## Response to Reviewers' comments

The revised manuscript by Bi & Shen details the protocol for the FbioCLIP-seq method. The clarification that this should be seen as a method pairing to the Mol Cell paper clarifies many issues, and I appreciate the language corrections addressing other concerns.

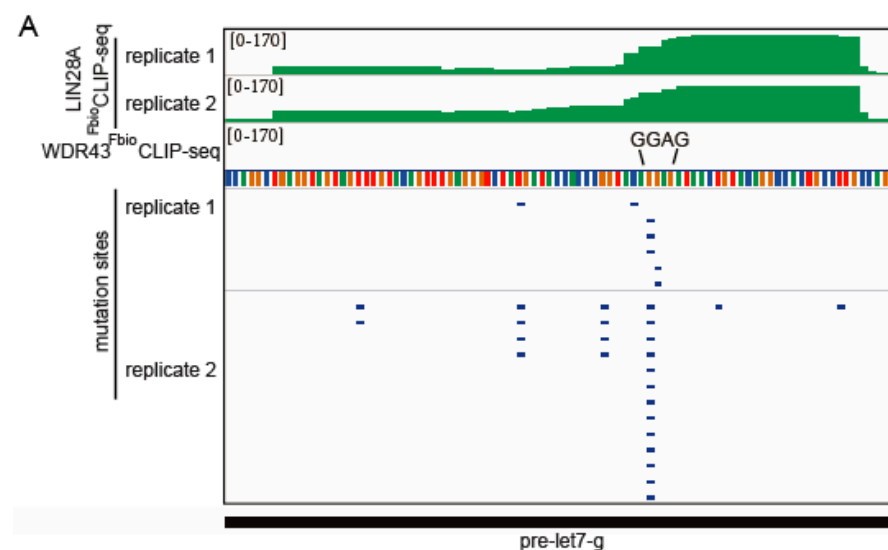
Figure 5D - what are the p-values (and fraction observation) of these motifs?

We have added the p-values and percentage of targets for the motifs in Figure 5D.

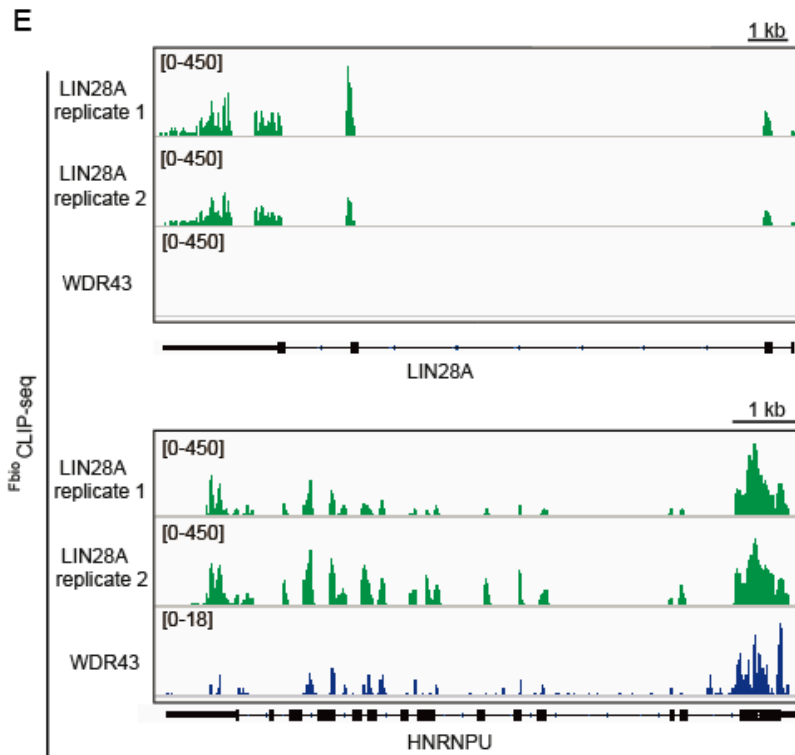
Figure 5A&E - having a non-LIN28 control here would help (I appreciate the addition of LIN28 to figure 6 in response to the prior review) - can the WDR43 data be included here as a negative control? I'm not clear that this figure shows anything without having some non-LIN28A control (whether total RNA-seq, wild-type with no tagged protein, or a different protein).

We have added the WDR43 result as a control in the Figures.

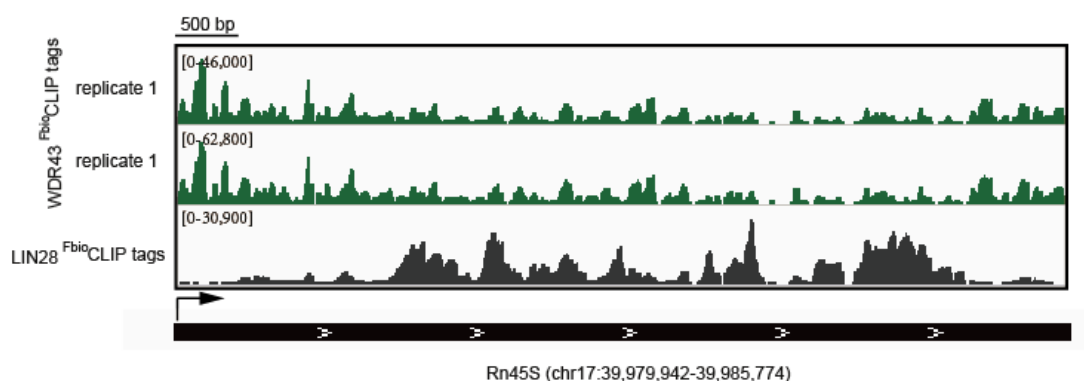
*Figure 5A-B - can the 4 positions highlighted in B be added in A? As displayed I'm not clear which bases in B reflect which positions in A.*

The GGAG sequences are labeled in the revised Figure 5A. Please refer to Response #2.
